Access Audit Site Report

Fort Parker State Park

Accessibility Evaluation

Inspection Date: 03/03/2022

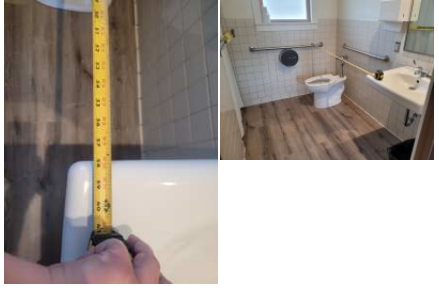
50	Group Barracks : Group Barracks - Lakeside Barracks Buildings (4)	[31.59189, -96.53038]	The operable part is not accessible because there is not adequate clear floor space for either a forward or side approach. The clear floor or ground space shall be 30 inches minimum by 48 inches minimum.	Beds obstruct access to cubbies	Remove, or relocate storage in CFS at fixtures and operable parts along the AR.	2015 ABAAS Section: 305.3 2012 TAS Section: 305.3 2010 ADAS Section: 305.3

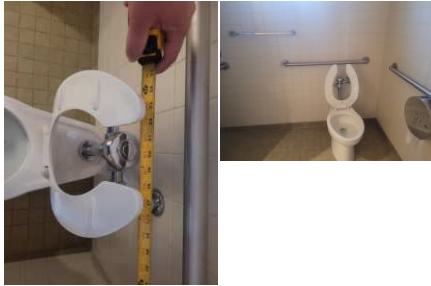
65	Group Barracks : Group Barracks - "Staff" Buildings	[31.5920728 , -96.530058 1]	The water and drain pipes under the lavatory are not adequately insulated. Water supply and drain pipes under lavatories and sinks shall be insulated or otherwise configured to protect against contact. There shall be no sharp or abrasive surfaces under lavatories and sinks.	restroom in barracks without kitchen- sink lacks insulated pipes	Insulate exposed pipes under one sink.	2015 ABAAS Section: 606.5 2012 TAS Section: 606.5 2010 ADAS Section: 606.5

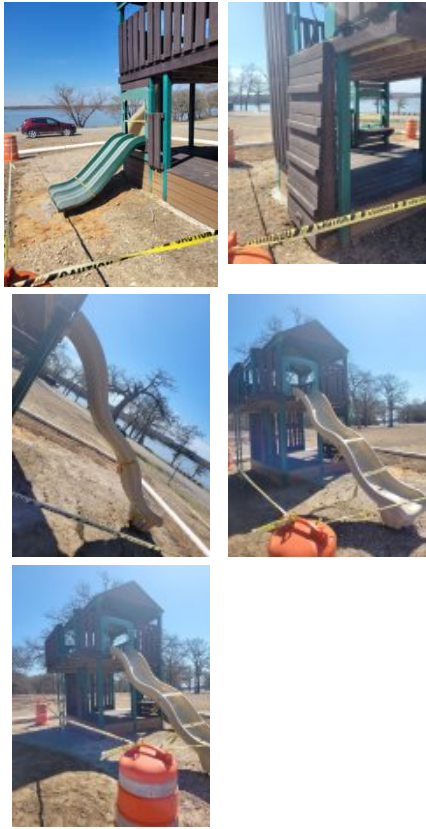
184	Park Site: Day Use Parking	[31.5974165, -96.5358651]	There are no or not enough accessible parking stalls. Each lot where parking is provided for the public as clients, guests or employees, shall provide accessible parking and shall be located on the shortest accessible route of travel from adjacent parking to an accessible entrance. There are a total of 30 parking stalls in the parking lot that could be reasonably associated with this facility. There should be a minimum of 2 accessible stalls with a minimum of 1 being designed as van accessible.	Parking at day use picnic by walking bridge lack identified parking spaces - approximately 30 standard, 0 accessible	Create one or more 8' accessible parking stalls, with one 5' adjacent access aisle, with proper signage and striping based on the total number of stalls.	2015 ABAAS Section: F208.2 2012 TAS Section: 208.2 2010 ADAS Section: 208.2

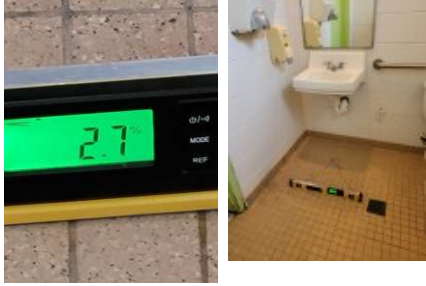
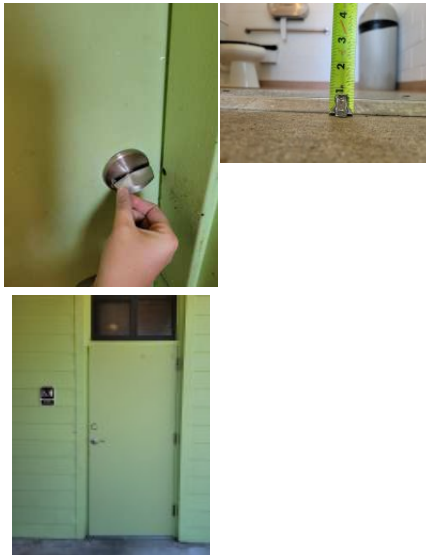
203	Green Restroom Building in Day Use Area: Green Restroom - Exterior Accessible Route	[31.596112, -96.536103 8]	The operable part is positioned too high for either a side or front approach. Where a clear floor or ground space allows a parallel approach to an element and the side reach is unobstructed, the high side reach shall be 48 inches maximum and the low side reach shall be 15 inches minimum above the finish floor or ground. Where a forward reach is unobstructed, the high forward reach shall be 48 inches maximum and the low forward reach shall be 15 inches minimum above the finish floor or ground.	Both vending machines at green restroom building - credit card slot at 55" AFF	Remount operable parts to be in reach range of 15" min to 48" max.	2015 ABAAS Section: 308.1 2012 TAS Section: 308.1 2010 ADAS Section: 308.1

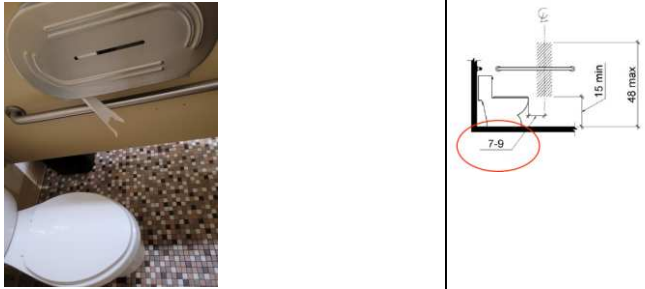
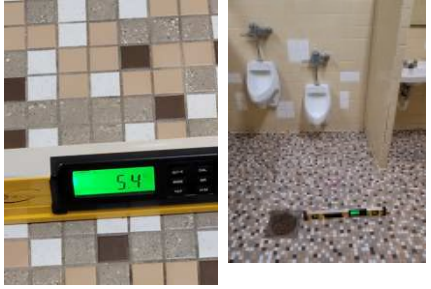
Finding Number	Area Description	Lat/Long	Finding	As Built	Recommendation	Citation	Photos	Figure
	Exterior Accessible Route					Section: 405.2 2010 ADAS Section: 405.2
